BLUE BIRD

You will find enclosed a copy of Service Bulletin S08MY regarding the positive jumper cable routing on your 2008-09 model year Blue Bird "Vision" buses equipped with 2007 Caterpillar engines.

Jumper Cable Routing

MODELS AFFECTED: 2008-2009 BBCV Visions w/ 2007 Cat Engines

Firewall (Engine Side)

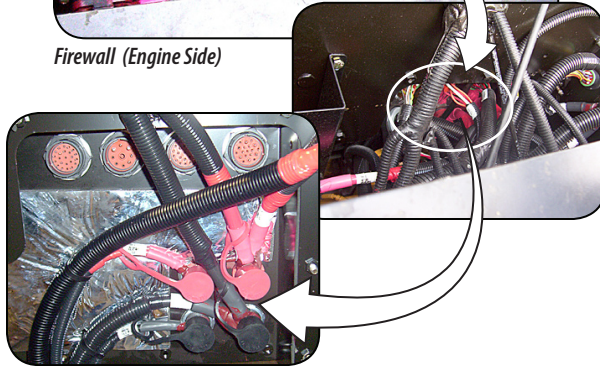
- 1 Park vehicle on a level surface, apply parking brake, turn engine off, remove ignition key and chock wheels.
- 2 Disconnect batteries.
- 3 Open engine hood and locate the Chassis Power and Electrical Power Studs.

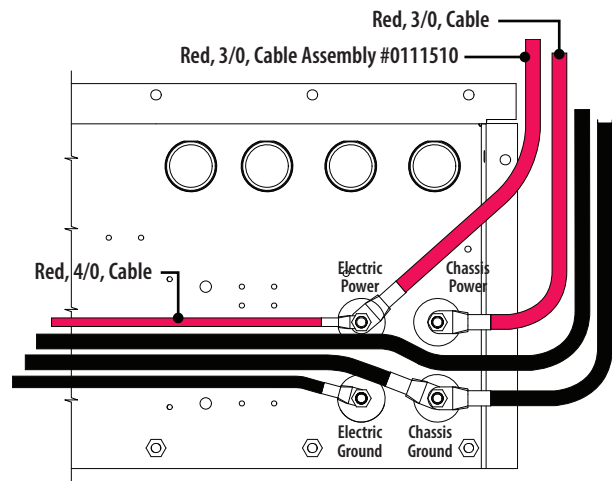
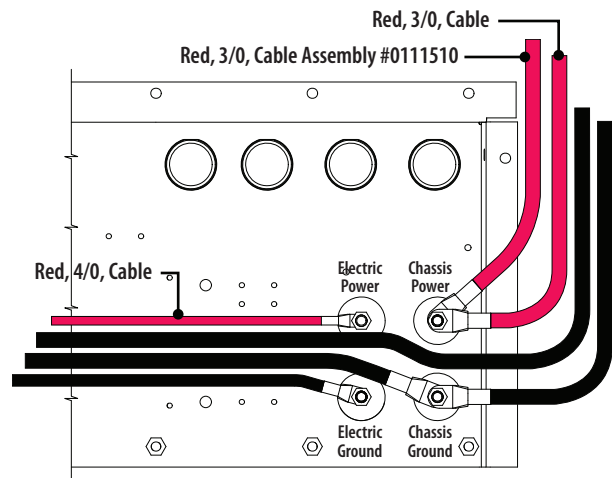
On these buses the positive jumper cable is routed incorrectly. As a result, the engine may experience shutdown after initial start up. To correct this condition, the jumper cable should be moved from the electrical power stud to the chassis power stud according to the instructions provided in Service Bulletin S08MY.

Engine may experience shut down after initial start up.

- 4 The lower end of Cable Assembly 0111510 should be attached to the Chassis Power Stud. If the cable is in this location, no further action required. If the lower cable end is attached to the Electrical Power Stud, remove it and attach it to the Chassis Power Stud.
- 5 Tighten both stud nuts to 11- 15 ft-lbs and apply a corrosion protection such as red glyptal.

Relocate positive jumper cable from Electrical Power Stud to Chassis Power Stud.
